DESIGN ADVISORY BOARD Tuesday, September 26th, 2017 at 3:00 PM Conference Room 12, City Hall, Burlington, VT Agenda

1. 18-0279CA; 184 Locust Terrace (RL, Ward 5S) Gabrielle Stebbins

MEMORANDUM

To: The Design Advisory Board
From: Mary O'Neil, AICP, Principal Planner
RE: ZP18-0279CA; 184 Locust Terrace
Date: September 26, 2017

Site Plan

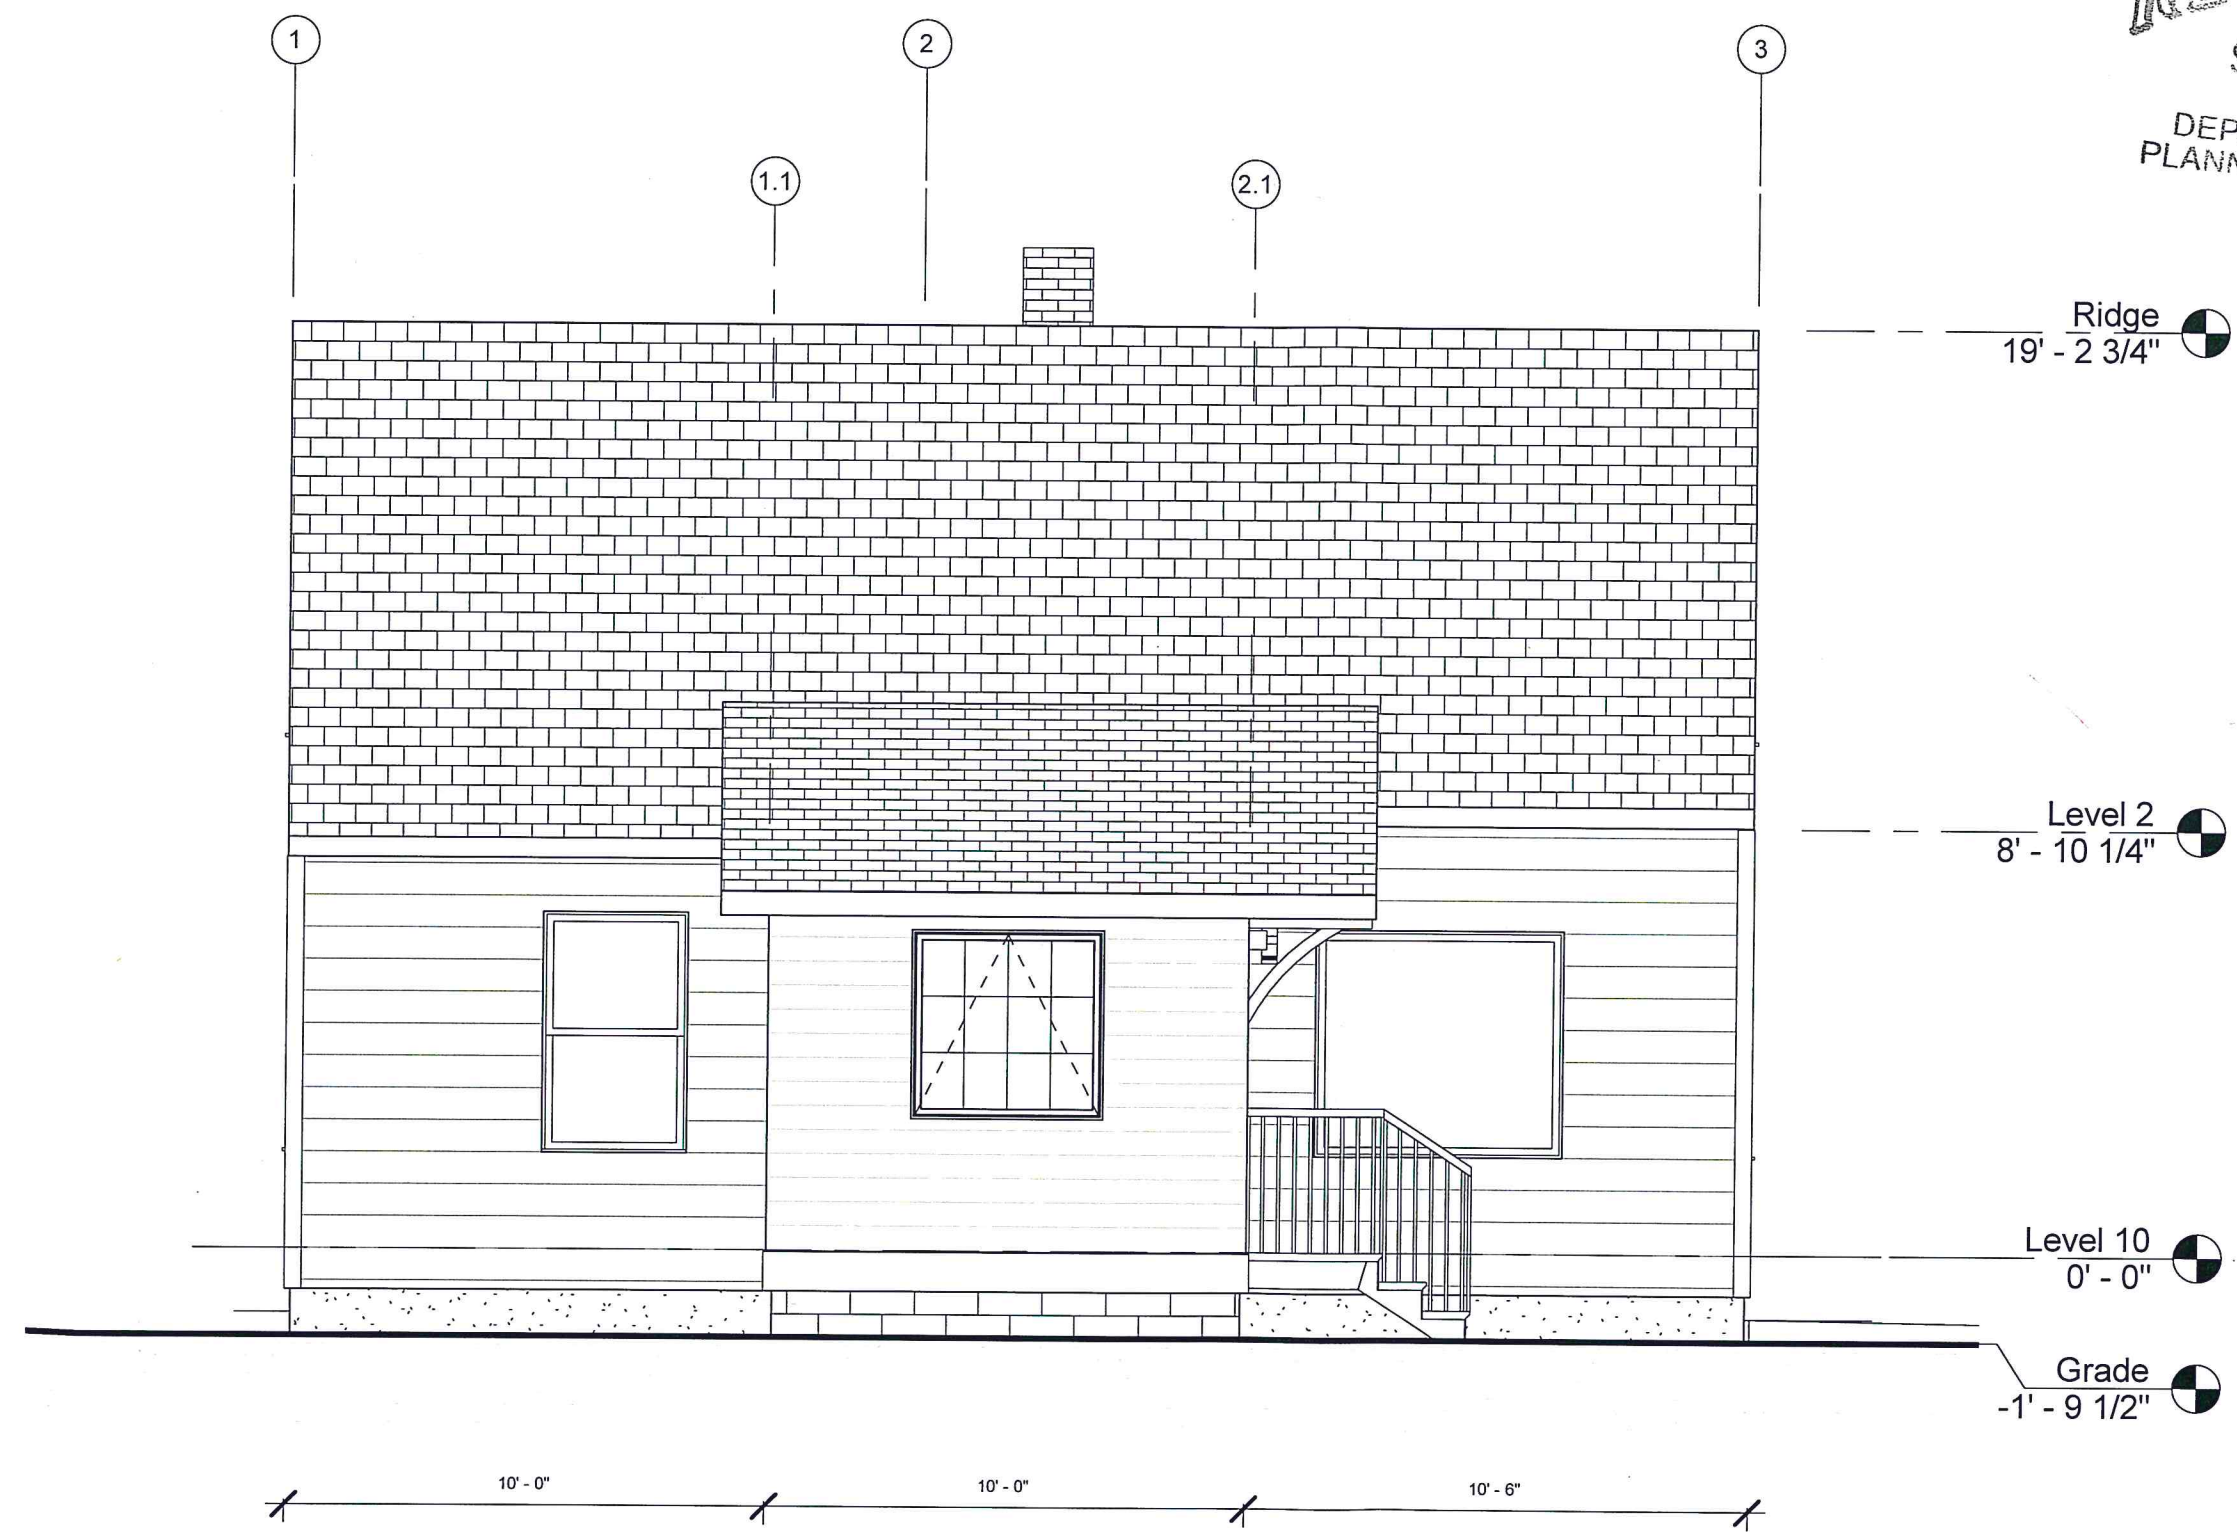
1. A site plan dimensional concern is the failure to observe a required front yard setback. (Article 4, **Table 4.4.5-3: Residential District Dimensional Standards.**) The average of front yard setbacks on adjacent lots on both sides is 23'. (21'9", 25'6", 20', and 25'.) Setback averages allow a +/- 5' deviation, creating an acceptable front yard setback range from 18-28' from the front property line. The proposed mudroom is 16'5 ½ "from the front property line; not within the range and therefore non-compliant.

Phase 1 Elev

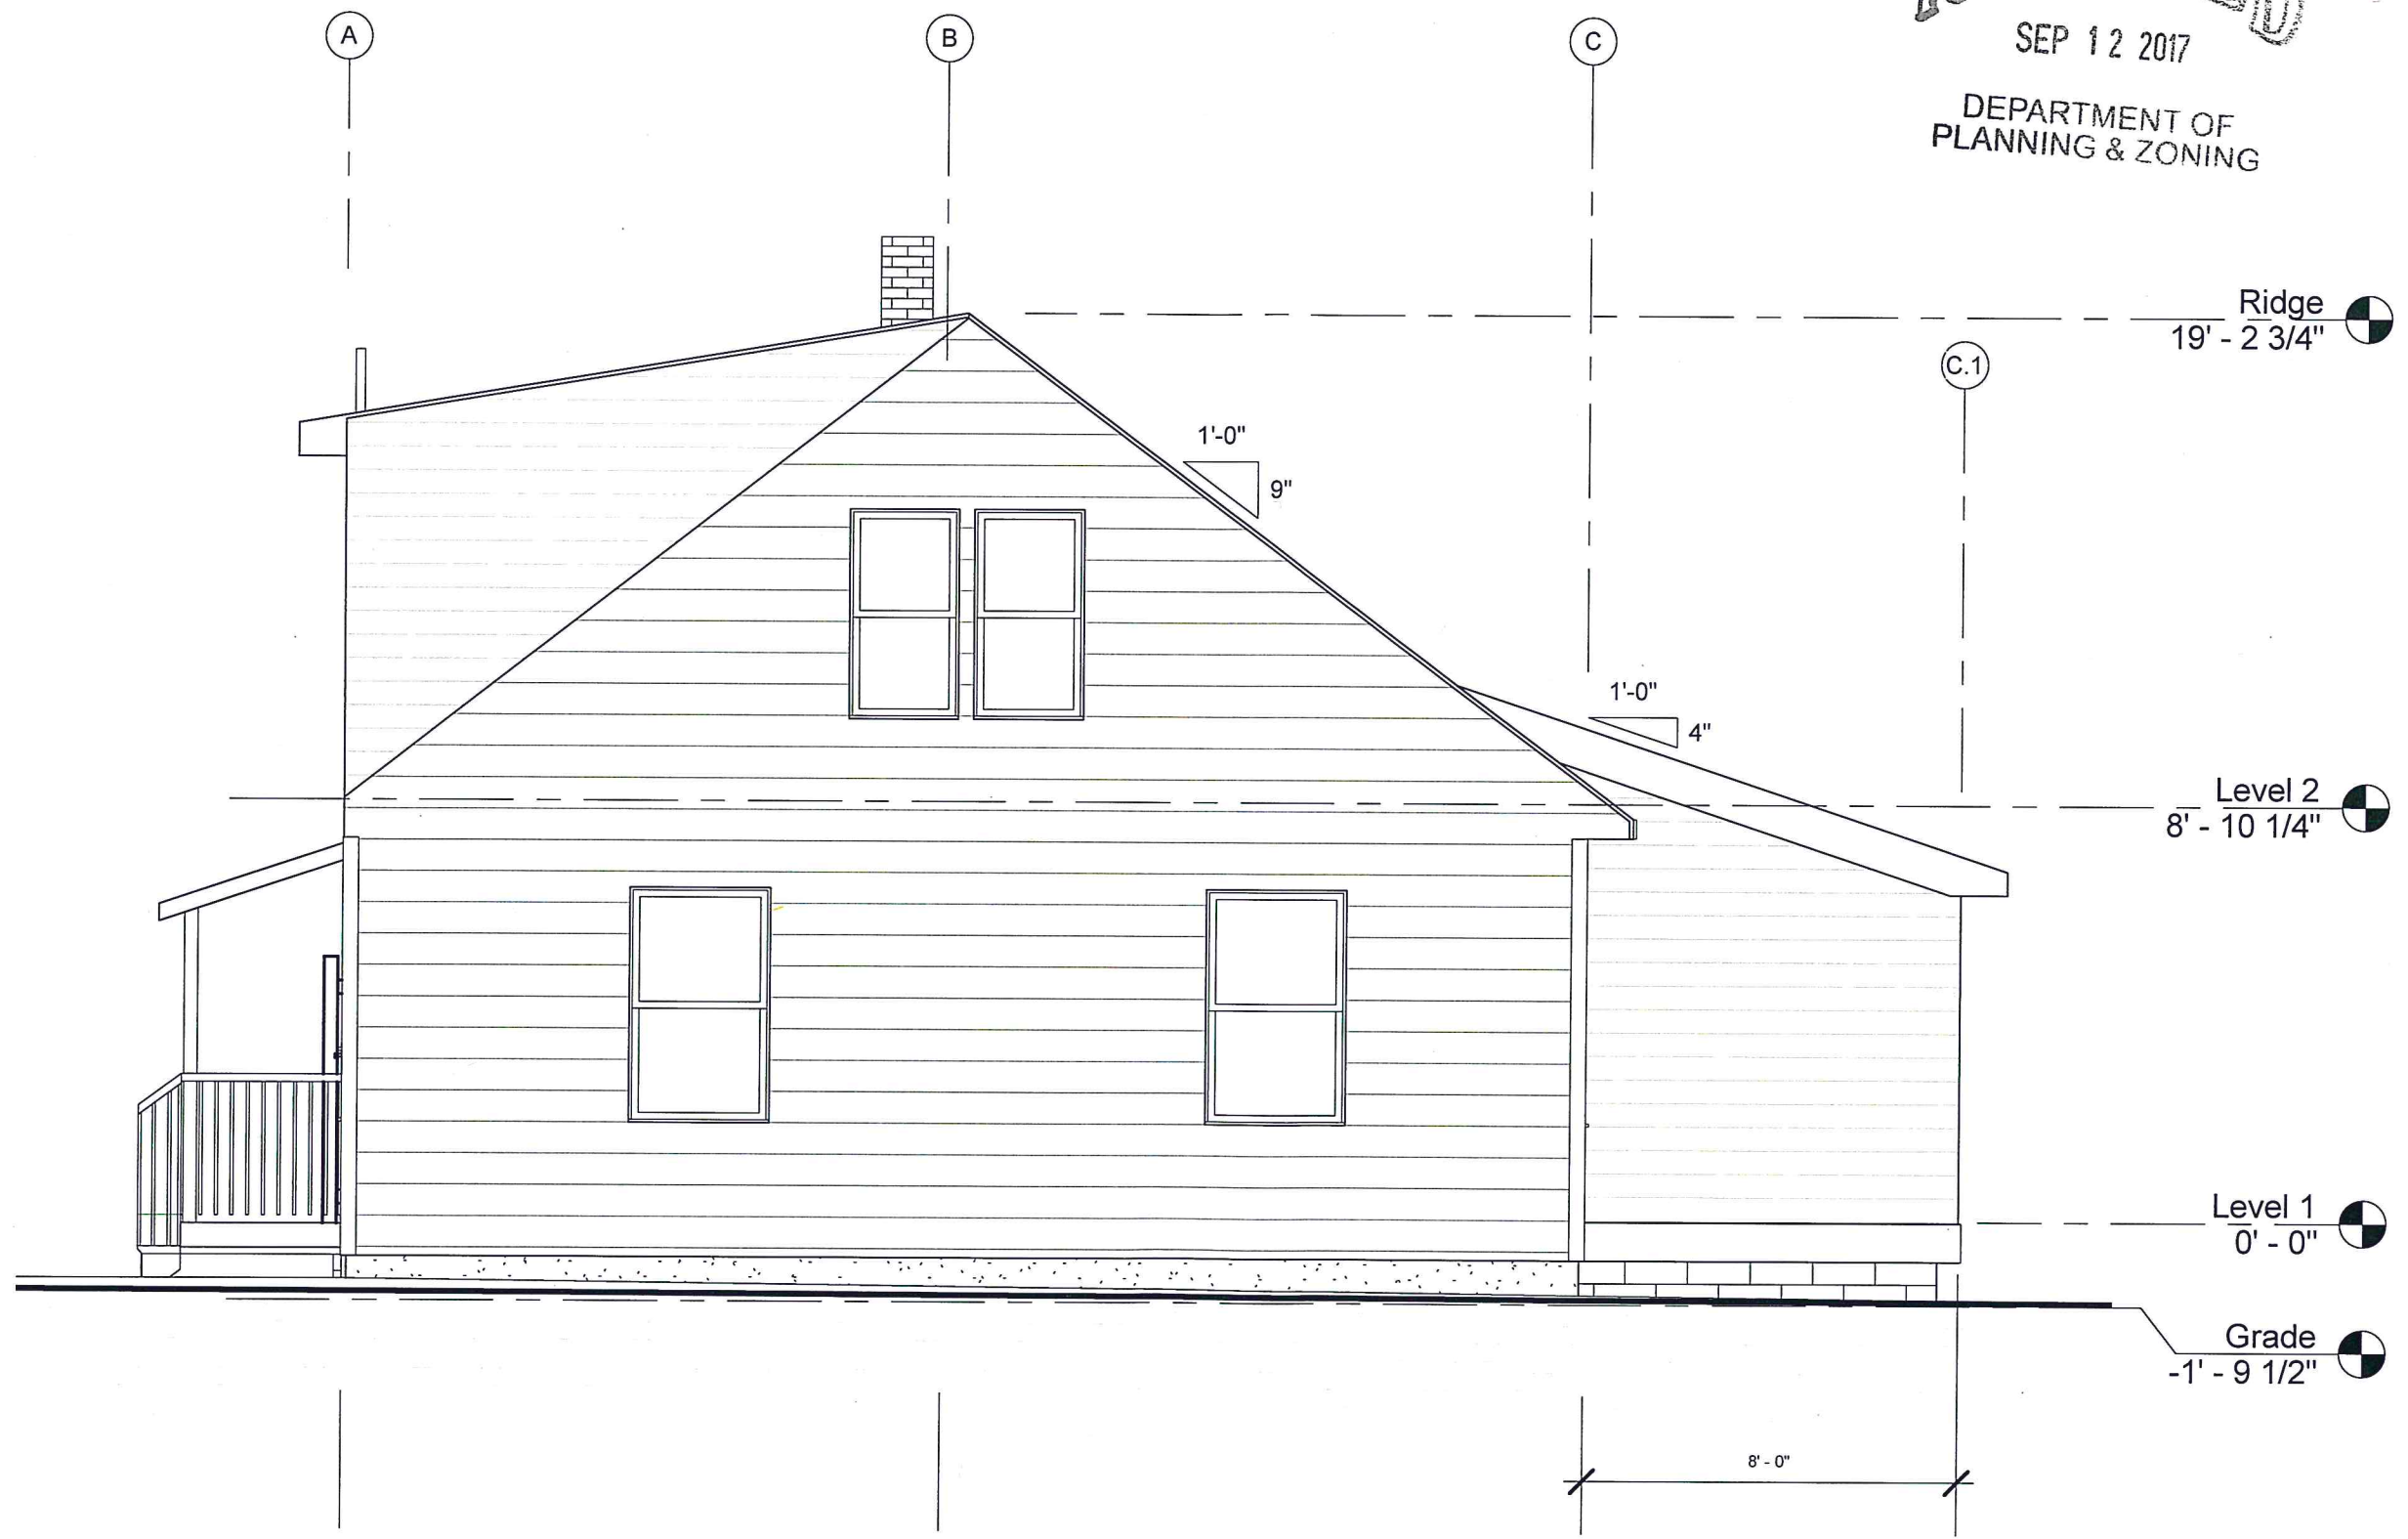
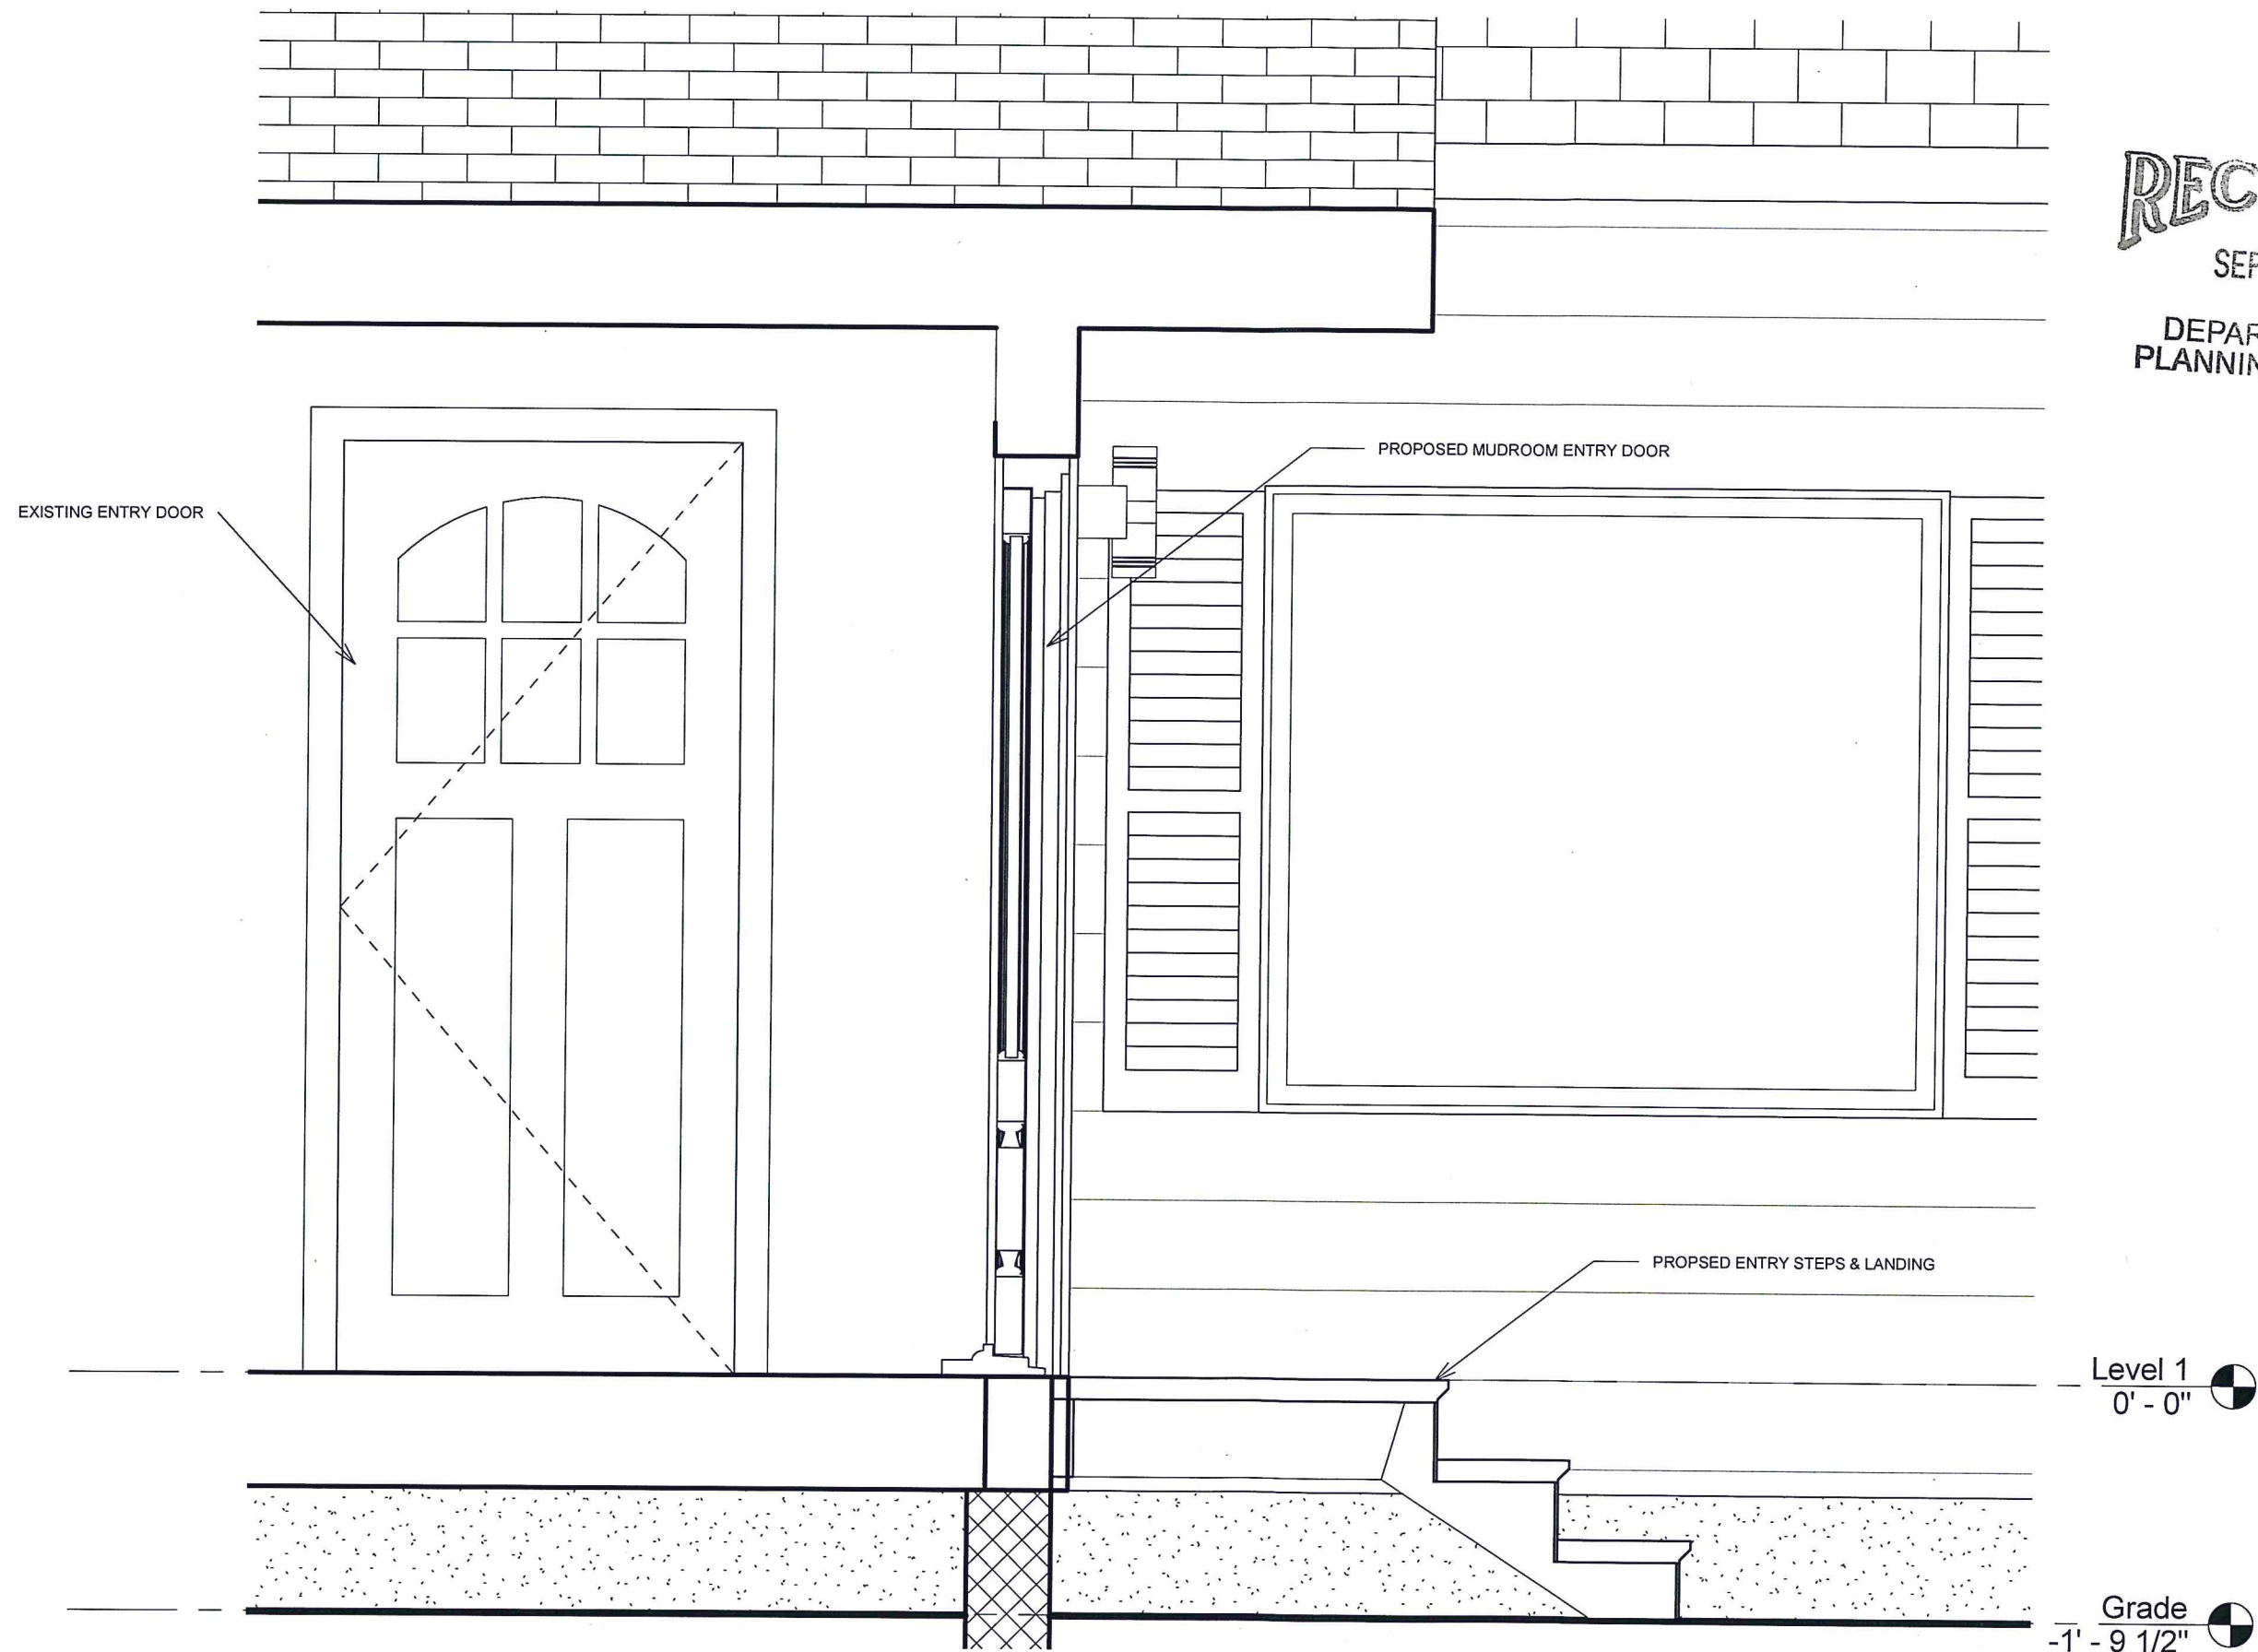
An exterior light is illustrated on plan A201. A spec sheet for the chosen fixture shall be submitted to staff for review and confirmation of conformity to Section 5.5.2.

A basic tenet of this section is having a front door face the street. The proposed mudroom moves the main entrance around the corner to the south of the addition, no longer readily identifiable from the street other than the handrails and stairs, contrary to this standard.

Windows are proposed across the easterly dormer façade only; cheeks remain windowless. The mudroom addition is proposed to have a single window on the west (front); with a door and window on the south.

The Assessor's record card lists the sheathing as vinyl. Plans do not define the proposed exterior materials, which need to be articulated.

Motion by Matt Bushey: I move the roof be revised to gable facing the street; location of door be relocated to west elevation. Mailbox and light shall be adjacent to the front door.
